Access Compliance Report

Public Rights-of-Way

(Curb Ramps)

Intersection ID: 2864	Main Street: ROCK_STREAM_DR	Cross Street: WAVERLY_LYNN_LN	Location:	E
ADA ID: B20BAB21D483	Ramp Type: BlendTrans1	Initial Pass/Fail: Fail	Overall Compliance: No	Severity Score: 8.75
Codes/Mitigation Info/Possible Solution		Field Measurements/Component Compliance

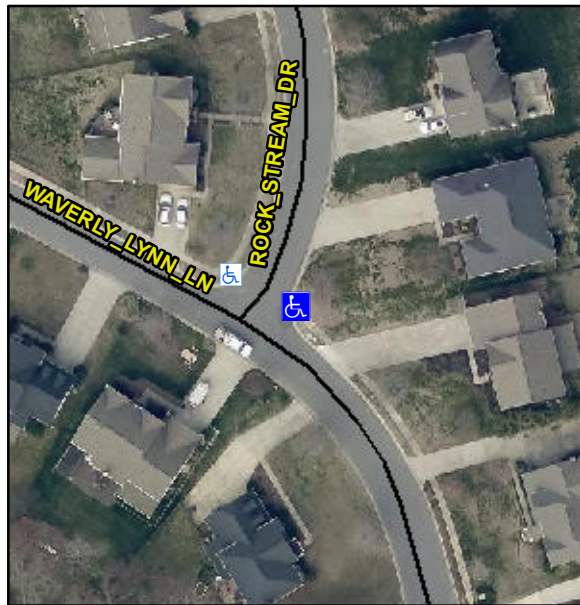
Not Found, R304.5.1

Remove & Replace Curb Ramp With Two New Directional Ramps or Equivalent.
